HE300 Fan Mounting Location

ADDENDUM

The following is an update to the Installation Manual (#69-2413) enclosed in this box.

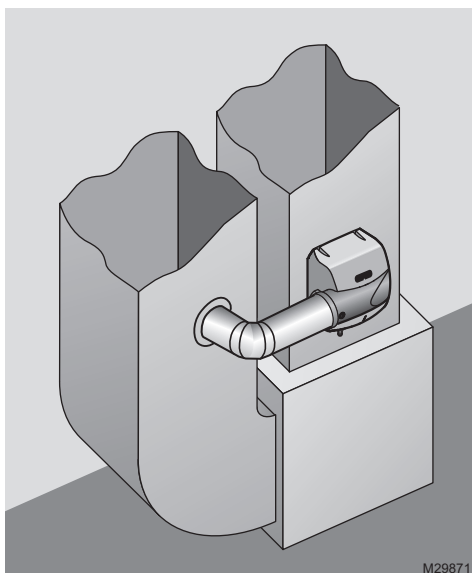
On page 5 of the Installation Manual (#69-2413), the mounting location for the **Fan** style HE300 humidifier indicates either a supply or return mounting location.

UPDATE: The HE300 Fan humidifier should only be installed on the supply duct.

Fan humidifiers use the fan inside the humidifier to pull duct air through the humidifier. Access to the **supply** is required. Do not mount on the return duct.
